Description of Use Addition to Dwelling  
RESIDENCE

RESIDENTIAL PLAN CORRECTION SHEET

ADDENDUM TO Permit No. 01827-(1)  
 Owner JOHN STOVESIC  
 Contractor RON ZACHRICH  
 Location 1220 W. RIVERVIEW

APPROVAL METHOD OF GROUNDING AND BONDING METAL VENEERS

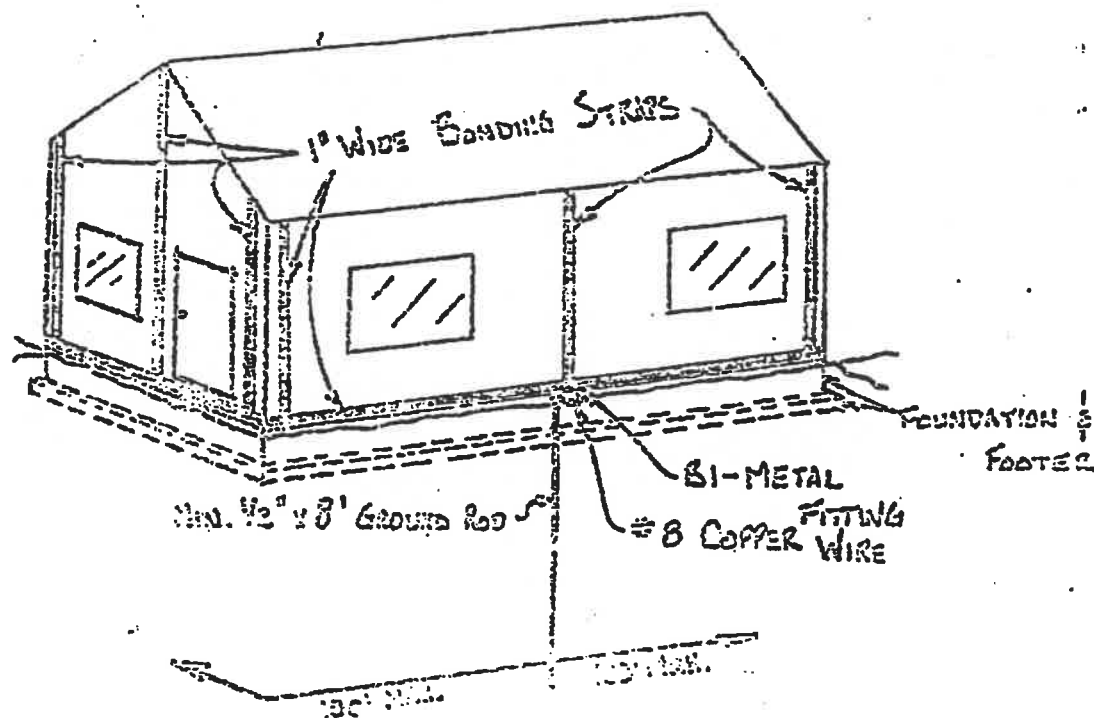
Additional Corrections. GROUND ALLOW SIDING PER INFO ATTACHED TO DWG'S.

1. Installation of bonding straps behind the siding must be inspected and approved by a representative of the Building Department prior to covering over with siding. Call 592-4010 for inspection.

2. All horizontal and vertical panel courses separated by a dielectric coating of film or otherwise shall be bonded with not less than a solid 1" wide bonding strap of the same alloy and of the same gauge or greater than the panel. Straps shall not have a dielectric coating of film or otherwise in order to maintain proper bonding.

3. The vertical straps shall be placed at all inside and outside corners, between all window and door openings, gable ends, etc., but not less than at 12' intervals. The vertical straps shall be bonded by means of a sheet metal screw to a horizontal strap that is continuously bonded around the perimeter of the structure.

4. When panels are applied over the vertical bonding straps at the points of overlap, the panels and bonding straps shall be bonded together by a panhead sheet metal screw of the same alloy.

5. Must use not less than #8 X 1" panhead sheet metal screw of the same alloy for bonding panels to straps. Nails are not acceptable for means of bonding.

5. At the lowest point of the panel overlap one vertical bonding strap to the exterior surface of the panel and then install a bi-metal fitting (such as a CU/AL Lug) to connect a minimum of a #8 copper wire conductor, attached to 1/2" in diameter by 8' long nonferrous ground rod. Provide a ground rod as prescribed, every 100' maximum intervals around the perimeter of the structure in order to maintain effective grounding. The use of an electrical service entrance ground rod is acceptable, provided a separate ground rod clamp is installed.
